Modification	At what stage is this document in the process?
<p>DCRP/MP/18/01/Report to Authority</p> <p>Revision to Engineering Recommendation P28 “Voltage fluctuations and the connection of disturbing equipment to transmission systems and distribution networks in the United Kingdom”</p>	
<p>The purpose of this report is to assist the Authority in its decision to implement the proposed modifications to the Distribution Code and Engineering Recommendation P28 (subsequently referred to as EREC P28). The proposed modifications were subject to industry consultation in January 2018. Responses from this consultation show that the industry is in favour of these modifications.</p> <p>Date of publication: 17th May 2018</p>	
<p>Recommendation</p> <p>The Distribution Code Review Panel (DCRP) and the distribution network licencees recommend that modifications are made to the Distribution Code and Engineering Recommendation P28, in relation to voltage fluctuations resulting from the connection of disturbing equipment to transmission systems and distribution networks in the United Kingdom that address the following:</p> <ol style="list-style-type: none"> Introduce requirements and planning level

Figure 5 — Voltage characteristic for frequent events (Category 1)

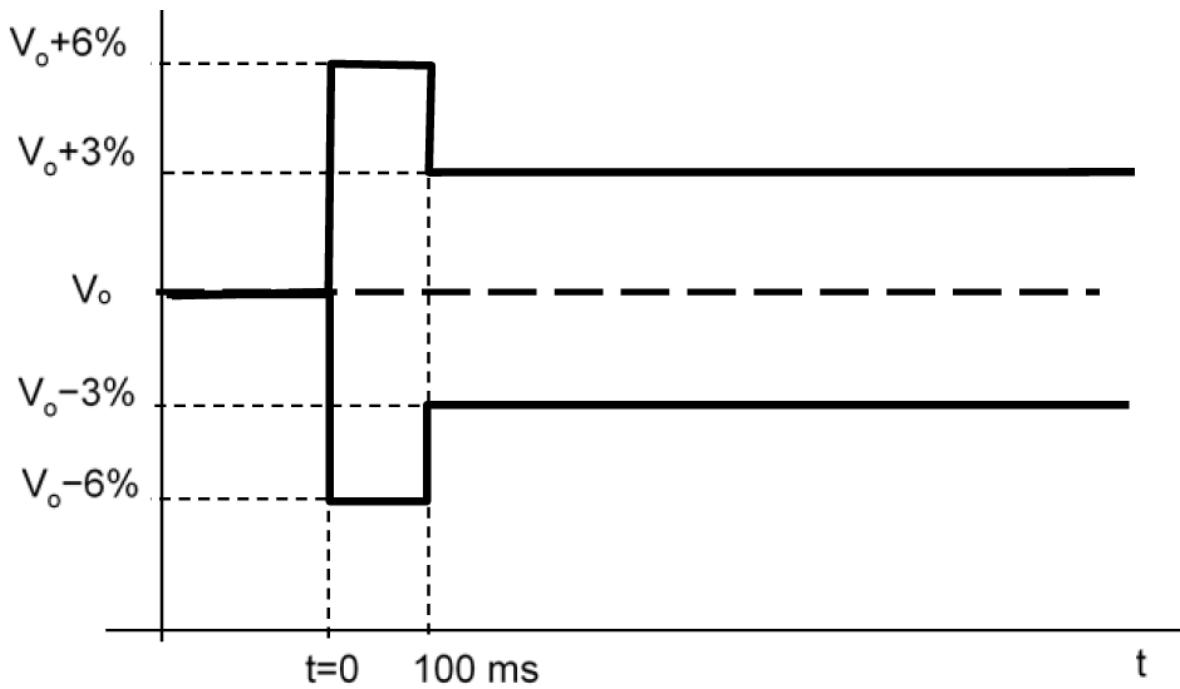
4.2.11 The minimum interval between frequent events fitting within the envelope in Figure 5 is determined by conformance to flicker severity (P_{st}) limits in EREC P28 Issue 2.

- Q1 Do you agree with the proposed requirements and planning levels for RVCs in EREC P28 Issue 2 (as provided in Figure 5, Figure 6, Figure 7 and Table 4 of EREC P28 Issue 2)?

- 5.6 However, two of the respondents provided extensive comments in relation to the proposed requirements and planning levels for RVCs as provided in Figure 5, Figure

6, Figure 7 and Table 4 of EREC P28 Issue 2 (see Question 1). The responses to Question 1 related to the following.

a) The apparent setting of planning levels the same as operating levels for the higher categories of RVCs concerned one respondent because when the network is not operating correctly, equipment could be constrained off for long periods due to external events causing them to trip off.

i) In response the Working Group believe there would be no realistic prospect of operation of the G59 undervoltage stage 1 protection for external RVC events that conform with the limits and requirements of EREC P28 Issue 2. Furthermore, the reference to "Commissioning, maintenance and post fault switching" in Table 4 of EREC P28 Issue 2 is an example of applicability. NOTE 7 in Table 4 states that these are examples only and that customers may opt to conform to the limits of another category providing the expected frequency of the events do not exceed the maximum frequency permitted for the chosen category. Commissioning, maintenance or post fault switching activities could be classed as Category 1, Category 2 or Category 3 events depending upon the maximum number of occurrences foreseen for those events.

Subsequent to their initial response the Working Group would point out that Table 4 of EREC P28 Issue 2 refers to planning levels for RVCs, which should be used for design and planning of connections. Whilst design pre-connection should be based on an expected number of both planned and unplanned RVCs over specified time periods to comply with Table 4, it is recognised that Users do not have control of the number of actual unplanned RVC events, including G59 trips, that could occur post connection.

Figure 6 — Voltage characteristic for infrequent events (Category 2)

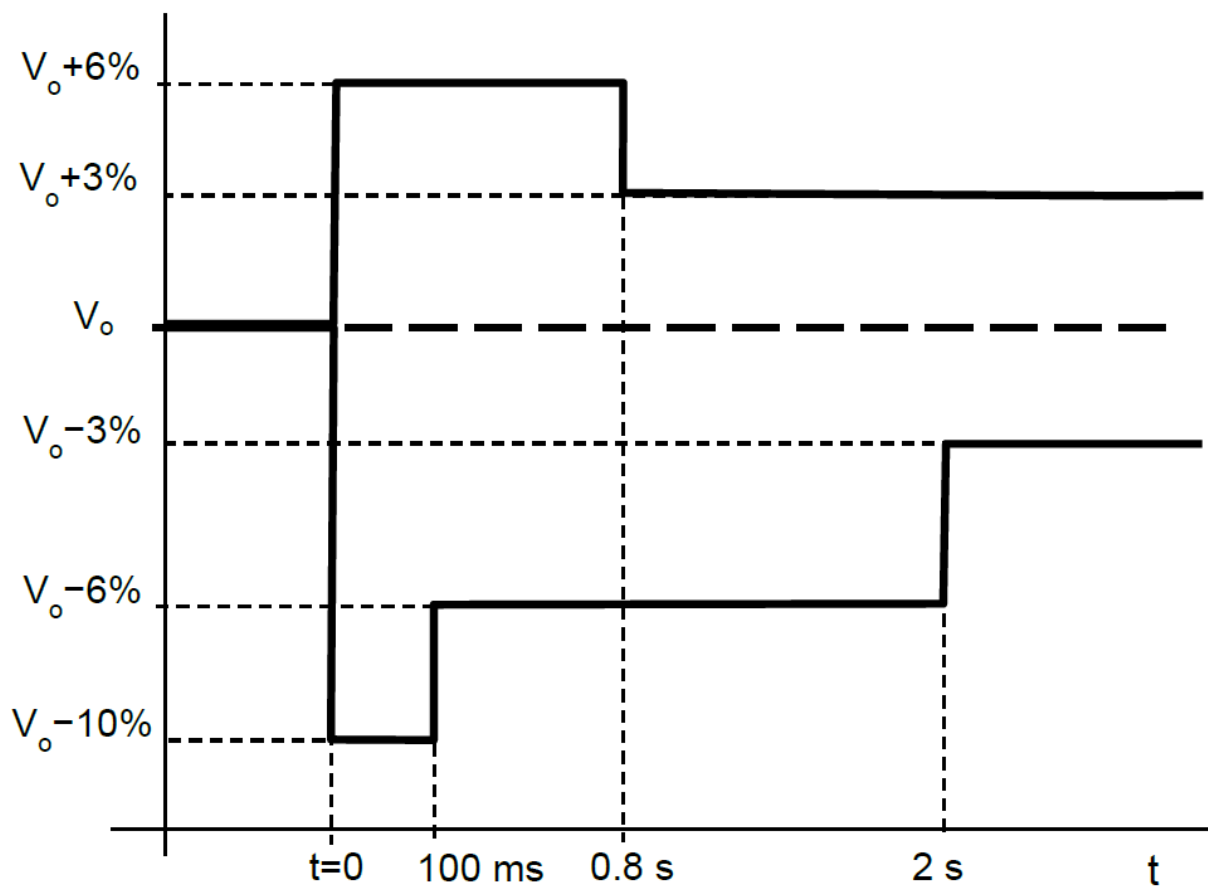
4.2.12 Up to 4 RVC events per calendar month are permitted for voltage fluctuations fitting within the envelope in Figure 6.

- EREC P28 Issue 2 introduces an intermediate category of RVC (Category 2) for 'infrequent events', where up to a maximum of 4 RVCs in one day are permitted not more frequent than 4 times per month providing the $\Delta V_{\max} \leq -10\%$ for ≤ 100 ms then reducing to $\leq 6\%$ for up to 2 s after initiation of the event (see Figure 6).

i) In response, the Working Group do not believe the requirements in EREC P28 Issue 2 are more onerous than Category 2 of Grid Code CC.6.1.7. The time and voltage magnitude limits for Category 3 RVCs shown in Figure CC.6.1.7 of the Grid Code when compared with Figure 7 of EREC P28 Issue 2 confirm that both the time and voltage limits in EREC P28 Issue 2 for Category 3 very infrequent events (not more than 4 RVCs in 1 day providing less frequent than once every 3 calendar months) are less onerous than those for Category 3 RVCs in the Grid Code.

- iii) In their response, the Working Group pointed out that the limits in Table 4 of EREC P28 Issue 2 and the associated amendments to the Distribution Code have been carefully chosen to allow a greater number and magnitude of RVC type voltage fluctuations than is currently permitted whilst not posing an unacceptable risk of voltage complaints from other customers connected to the system. It would not be acceptable to increase the RVC limits proposed for Category 2 and Category 3 events in EREC P28 Issue 2 simply to avoid the need for disturbing equipment connectees to mitigate unacceptable voltage fluctuations caused by the energisation of their equipment, where these fluctuations could cause an unacceptable risk of interference to other customers.

Figure 7 — Voltage characteristic for very infrequent events (Category 3)

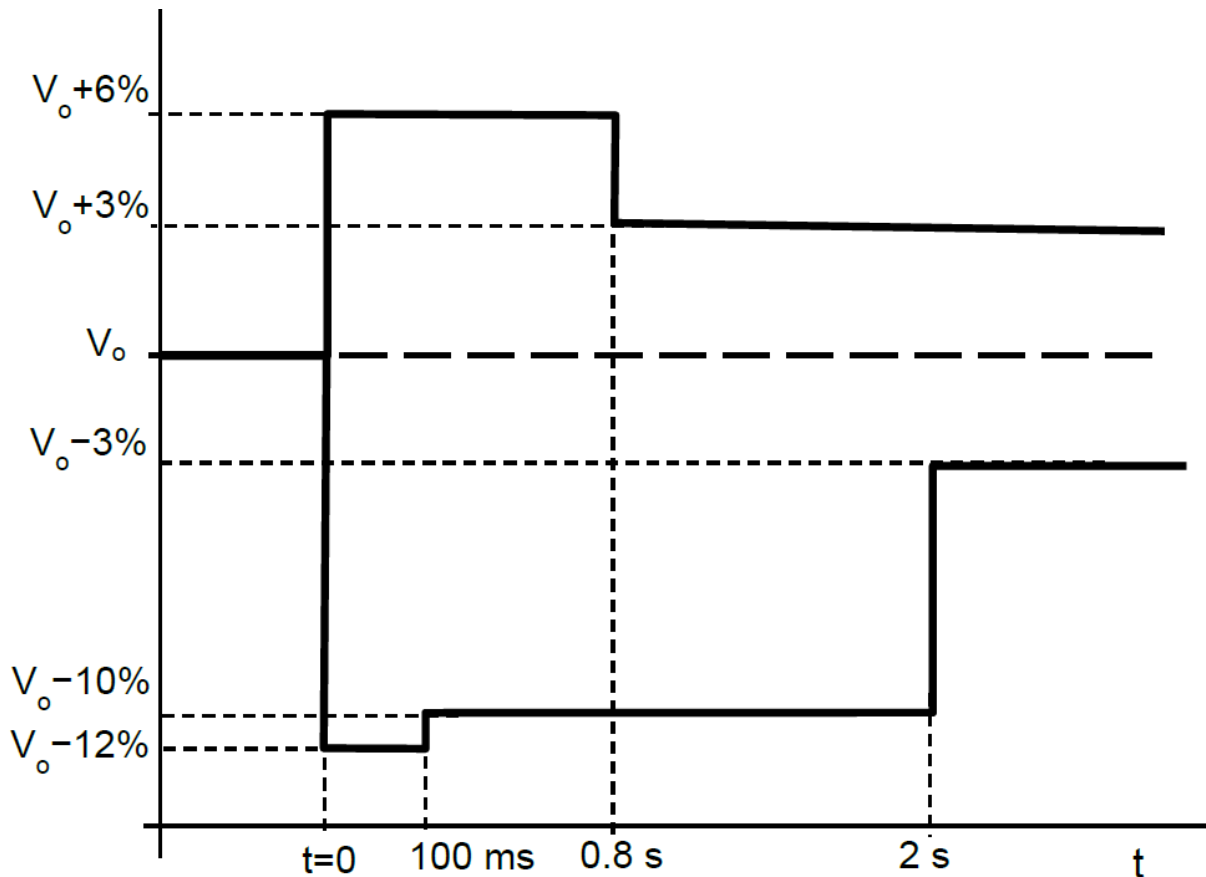
4.2.13 The limits for RVCs proposed in EREC P28 Issue 2 take into account those in the recent GC0076 modification to the Grid Code.. It should be noted that the intention is to align the requirements in the Grid Code with those in EREC P28 Issue 2, which will provide greater flexibility for customer connections and will be less onerous to comply with for customers. The key differences between the requirements in EREC P28 Issue 2 and those in the Grid Code are as follows:

- Allowable voltage changes are expressed as a percentage of nominal voltage (V_n) in P28 Issue 2 as opposed to a percentage of the initial voltage (V_o) in the Grid Code. The intention being to align with the approach taken in National and International Standards.
- For increases in voltage:
 - EREC P28 Issue 2 proposes a limit on the maximum voltage change between two steady state conditions of $\Delta V_{\max} \leq 6\%$ for a maximum duration of 0.8 s from the initiation of a voltage change.
 - The Grid Code has a limit of $\Delta V_{\max} \leq 5\%$ for a maximum duration of 0.5 s.
- For decreases in voltage:
 - EREC P28 Issue 2 proposes a time limit of 100 ms from initiation of a

voltage change during which the maximum voltage change permitted (-12% for 'very infrequent events' and -10% for 'infrequent events') can persist.

- The Grid Code has a time limit of 80 ms from initiation of a voltage change during which the maximum permitted voltage change is -12%.
- For increases and decreases in voltage, EREC P28 Issue 2 permits a greater maximum number of occurrences for Category 3 'very infrequent' events:
